REGULAR MEETING OF THE DESIGN REVIEW BOARD

4. Public Hearing - 10534 San Pablo Ave Design Review

Application: PL15-0097
Applicant: I. Kuan Choi
Location: 10534 San Pablo Avenue
APN: 503-233-015
Zoning: TOMIMU (Transit Oriented Mid-Intensity Mixed Use)
General Plan: TOMIMU (Transit Oriented Mid-Intensity Mixed Use)
Request: Design Review Board consideration of exterior changes to an existing building and construction of a new mixed-use building containing 1 commercial unit, 1 live/work unit and 4 residential units.
CEQA: Categorically Exempt, Section 15332, Class 32: In-Fill Development Projects

Application: PL15-0097
Applicant: I. Kuan Choi
Location: 10534 San Pablo Avenue
APN: 503-233-015
Zoning: TOMIMU (Transit Oriented Mid-Intensity Mixed Use)
General Plan: TOMIMU (Transit Oriented Mid-Intensity Mixed Use)
Request: Design Review Board consideration of Tier II Design Review for exterior changes to an existing building and construction of a new mixed-use building containing 1 commercial unit, and 5 residential units.
CEQA: Categorically Exempt, Section 15332, Class 32: In-Fill Development Projects

A9

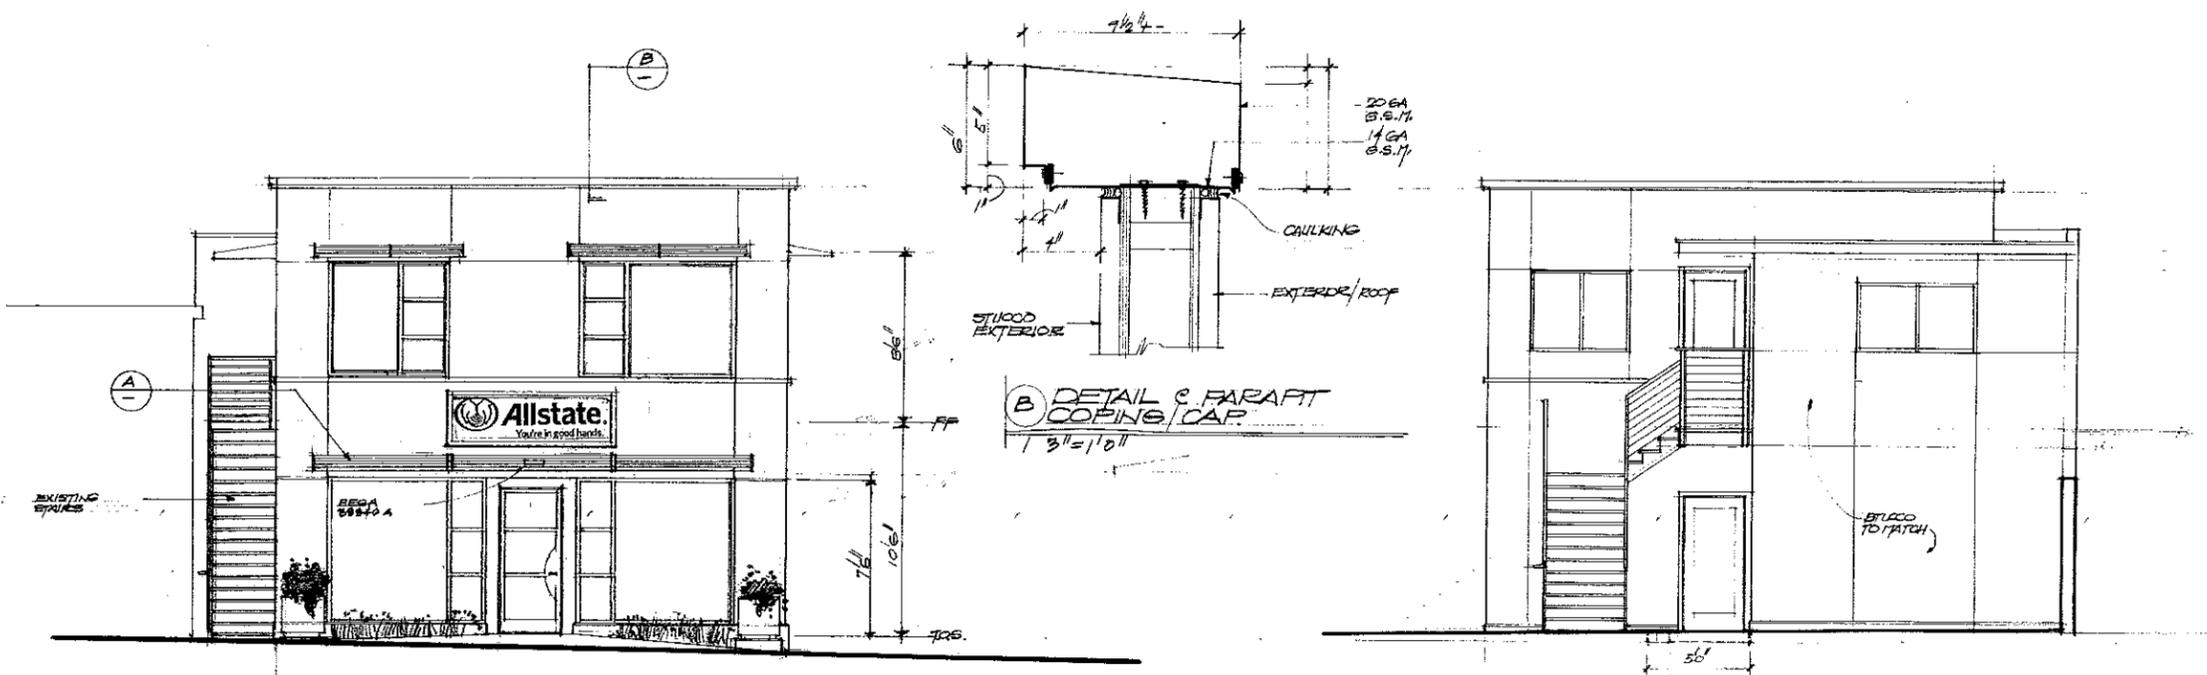
- Comment: The existing building should utilize the same design language as the proposed new building. Specifically, the existing building should feature aluminum storefront windows similar to those proposed for the new building. It was suggested that the existing building also feature similar patterning in the stucco as that proposed for the new building.

- Comment: A simpler cornice should be utilized on the existing building in order to be more consistent with the architecture of the new building. The Board suggested that 8 inches was the appropriate dimension for this cornice.

- Comment: A flat accent similar to the cornice should be used above the entry of the existing building.
Response: Flat metal sunshades have been added above the main entry as well as above the windows on the upper floors.

Response: Aluminum storefront windows have been added to San Pablo Avenue frontage of the downstairs commercial space. Additionally, the plans show new windows on the upper floor residential unit as well. The plans contain the notation “New Windows Per DRB.” However, the materials for the upper story windows is unclear. Since the Board seemed to desire aluminum windows to match the proposed building, staff has included a condition of approval in the draft resolution that requires anodized aluminum windows throughout both buildings. In addition, similar patterning in the exterior stucco has been added to the existing building.

Response: The cornice on the existing building has been redesigned to have a more streamlined and modern look. The cornice is proposed to overhang 4 inches with a height of 6 inches (see detail on Page A10).
